# Access Compliance Report

## Public Rights-of-Way

Intersection ID: 12638	Main Street: KENSINGTON_DR	Cross Street: THOMAS_AV	Location: NE
ADA ID: DB3903E80FEB	Ramp Type: Directional1	Initial Pass/Fail: Fail	Overall Compliance: No
Codes/Mitigation Info/Possible Solution		Field Measurements/Component Compliance	
Severity Score: 21.25

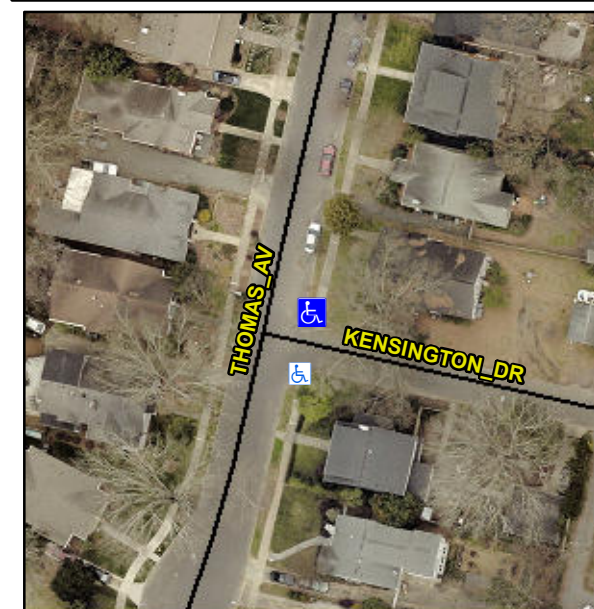
**R304.5.1, R304.5.3**

**Remove & Replace Entire Ramp.**
